<b>Docket Number:</b>	21-AFC-02
<b>Project Title:</b>	Willow Rock Energy Storage Center
<b>TN #:</b>	261315
<b>Document Title:</b>	Willow Rock CURE Data Request 2 Response
<b>Description:</b>	N/A
<b>Filer:</b>	Kathryn Stevens
<b>Organization:</b>	WSP USA Inc.
<b>Submitter Role:</b>	Applicant Consultant
<b>Submission Date:</b>	1/27/2025 4:45:40 PM
<b>Docketed Date:</b>	1/27/2025

**Willow Rock Energy Storage Center (21-AFC-02)**  
*California Unions for Reliable Energy (CURE) Data Request Response Set 2*

Figure DR142-1: Recorded Flow Rate (left) and Permeability (right) in Core Hole ZEV-CH-06-24

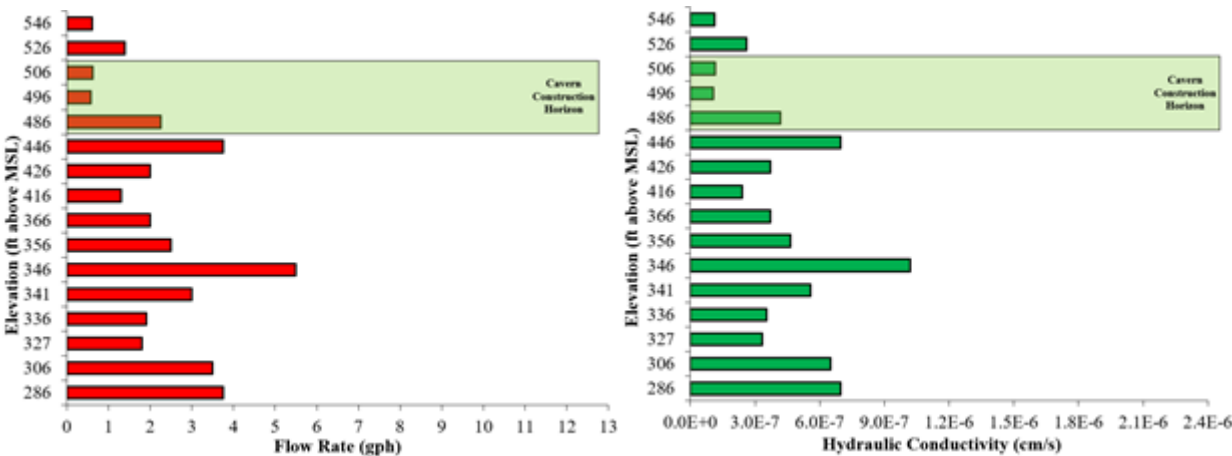
**DR142:** If the packer testing in the sixth deep exploration borehole is complete, disclose the findings from the packer testing in the sixth deep exploration borehole.

**Response:** The packer testing flow rates and resultant formation permeability data from the sixth hole is presented in the bar graph plots below, where the proposed cavern horizon is also identified. The results are consistent with packer permeability dataset obtained from the previous five boreholes and indicate a very tight geologic formation.

Annual Wind Field Flow Pattern and 5-year Wind Rose Figures

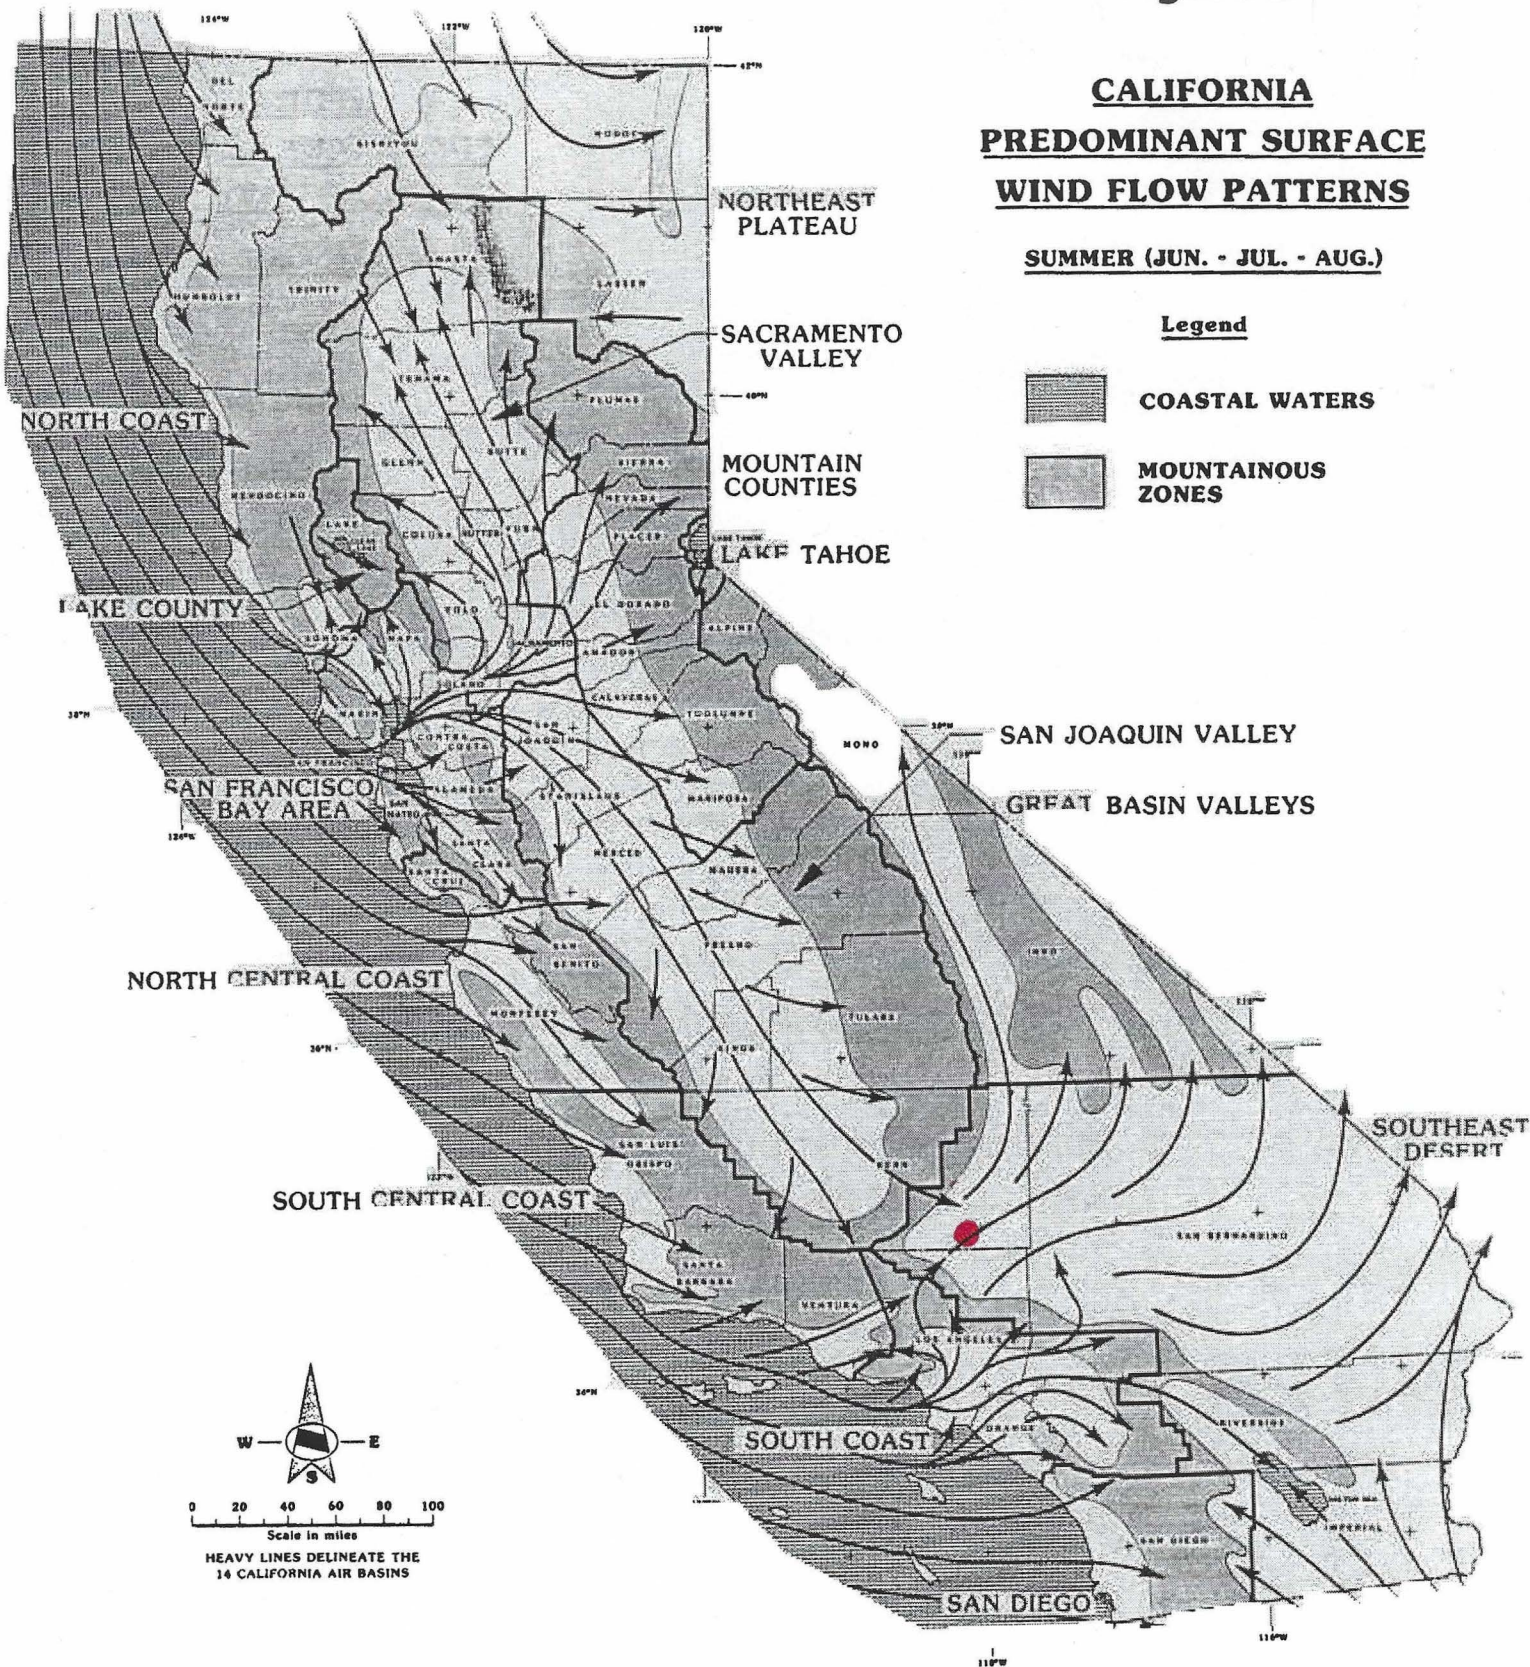
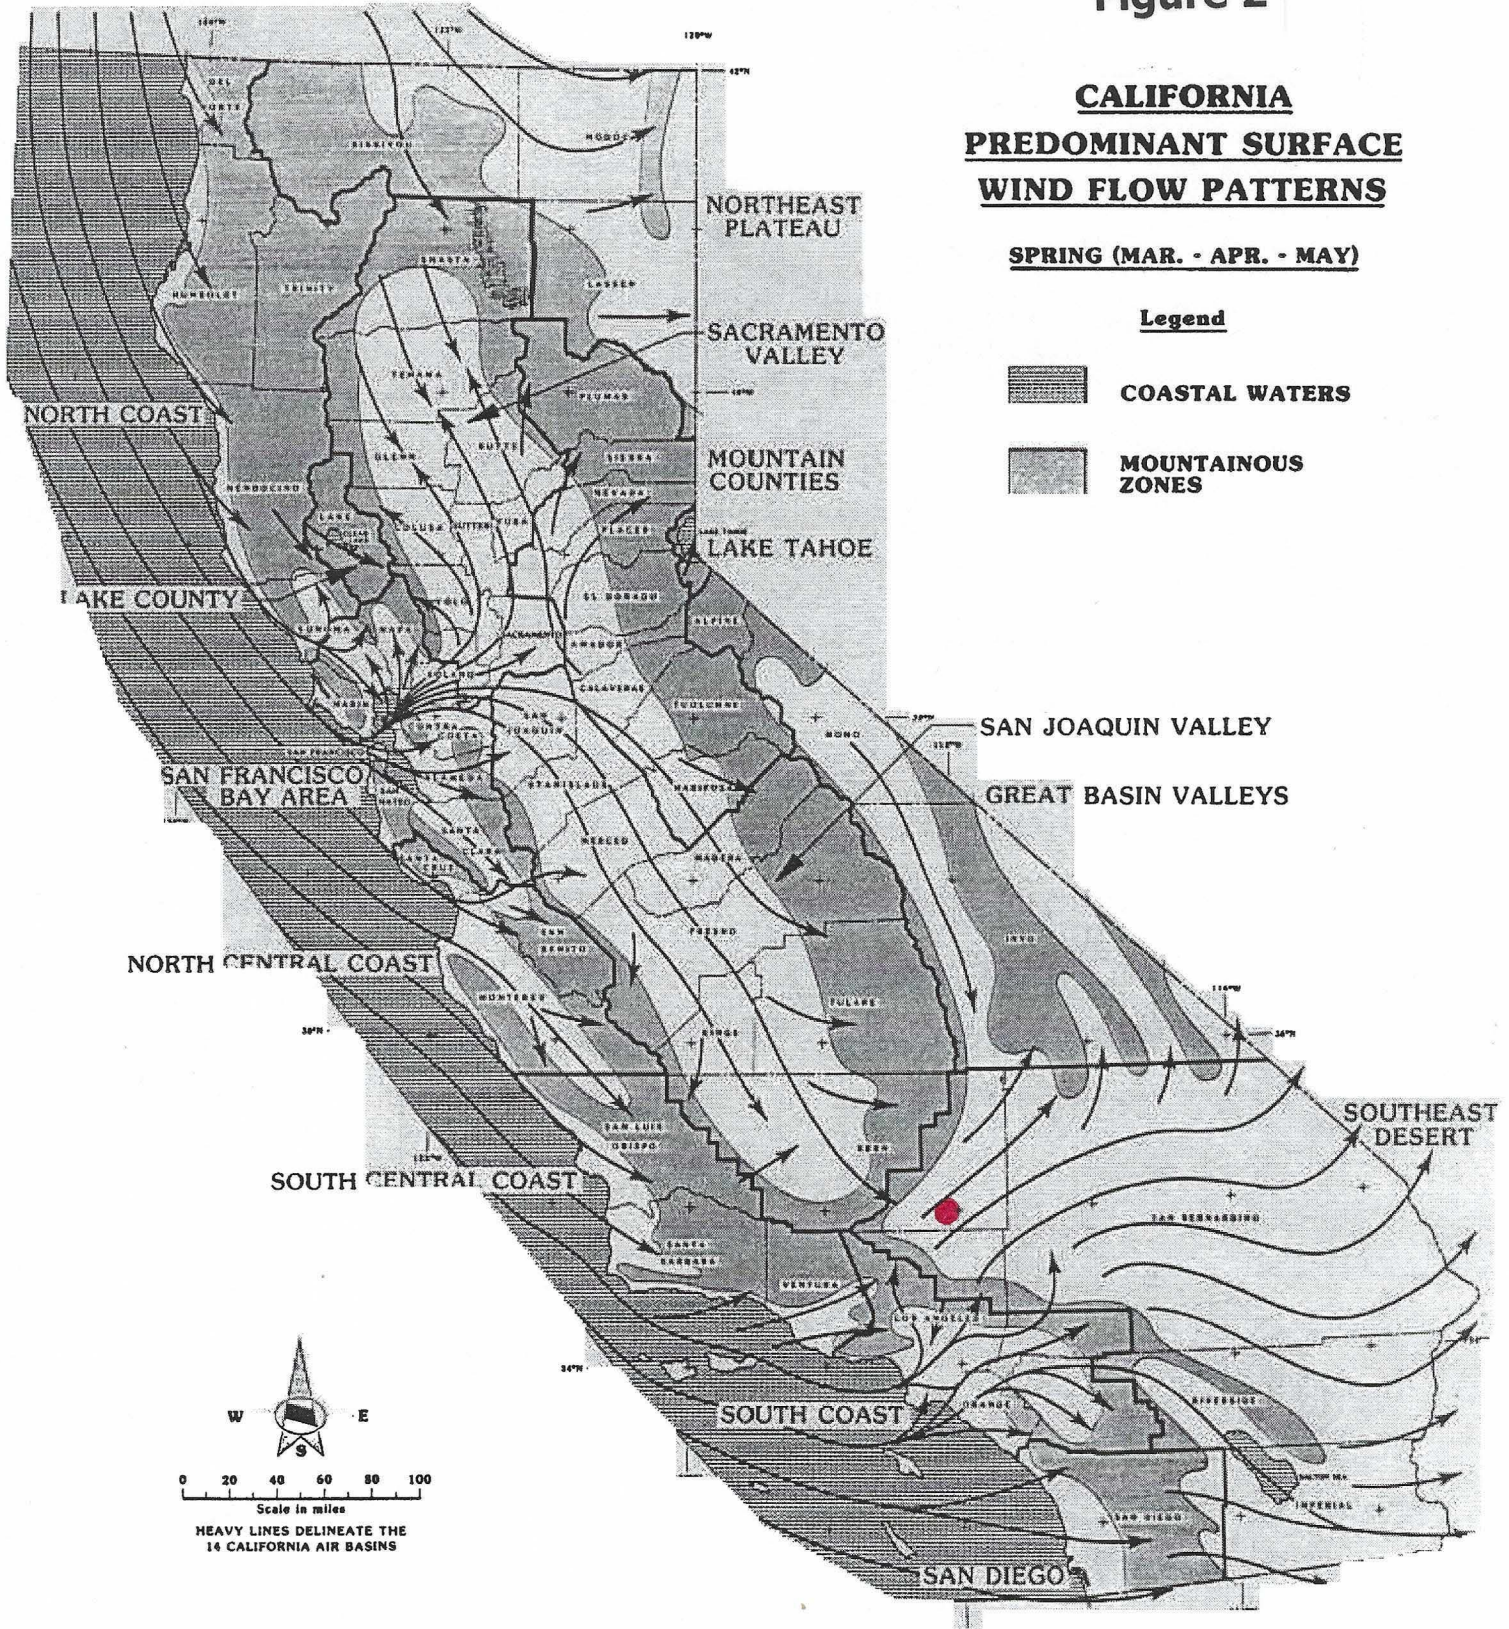
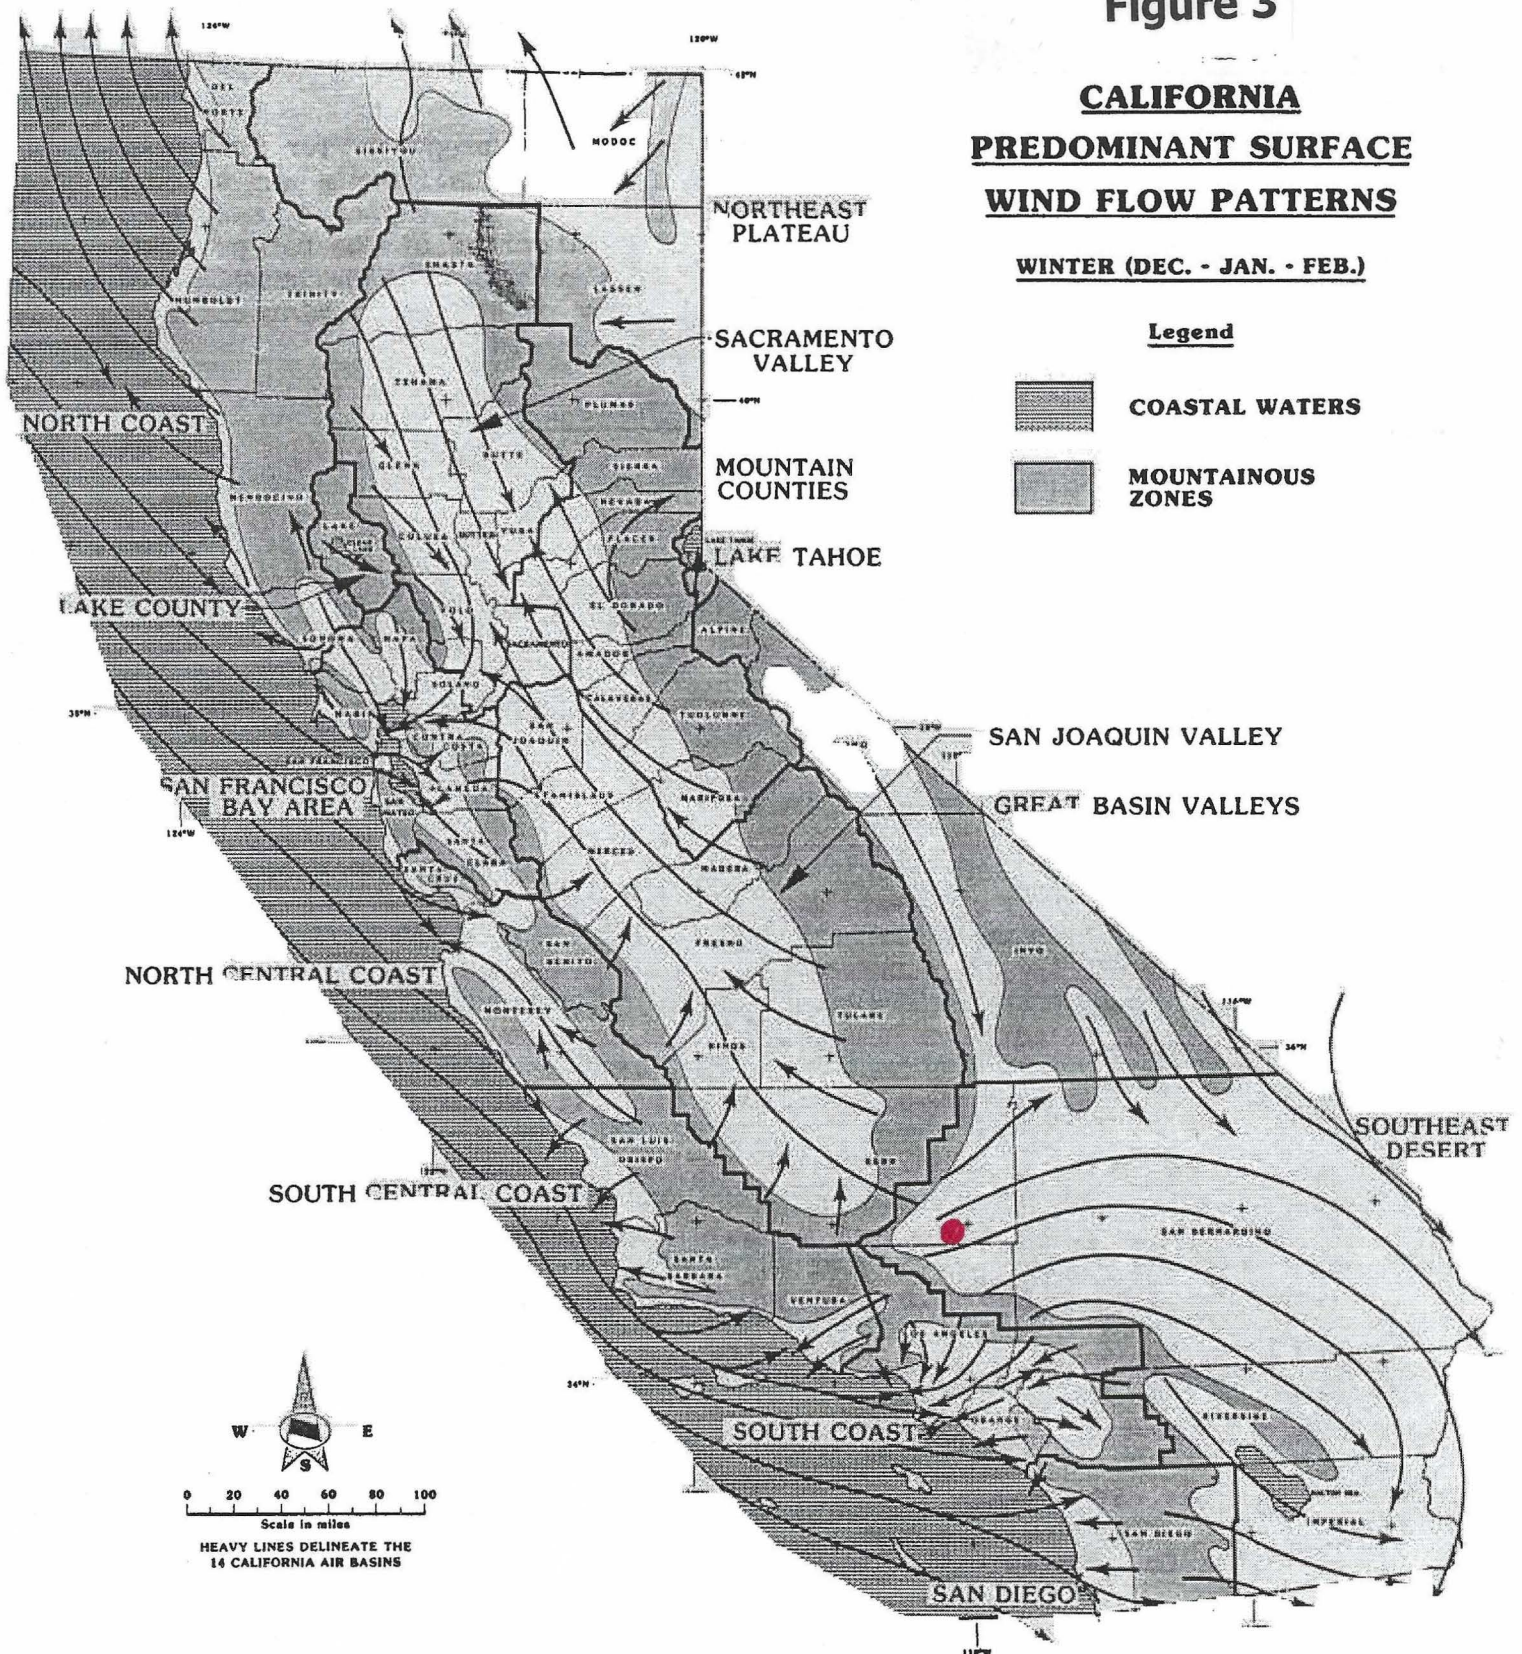
**DR107:** Explain why three monitoring stations are used to assess criteria pollutant concentrations.

A review of the California Air Resources Board (CARB) historical wind fields as well as the 5-year wind rose prepared by the Applicant's consultant, and included in **Attachment DR107-1**, indicates that an overwhelming percentage of winds originate from the west-northwest through southwest. Lancaster lies approximately 16 miles to the south-southeast of the project site, while Palmdale lies approximately 24 miles to the south-southeast of the project. The Mojave 58 Business site lies approximately 12.9 miles north-northeast of the proposed project site. Based on **Table DR107-1** monitoring site locations and the annual wind field flow patterns (**Attachment DR107-1**), neither Lancaster nor Palmdale background air quality will influence the project site background concentrations in any meaningful way as a majority of these concentrations will be transported towards the east, away from the proposed project site. However, for NO<sub>2</sub> and CO background data, Lancaster was the only monitoring station within the air basin and was selected in part due to the heavily urban-influenced concentration data the Division Street monitoring station collects. Thus, use of this background data would conservatively characterize the site air quality for purposes of the modeling study. Note that background CO monitoring data is no longer collected within the air basin after 2021.
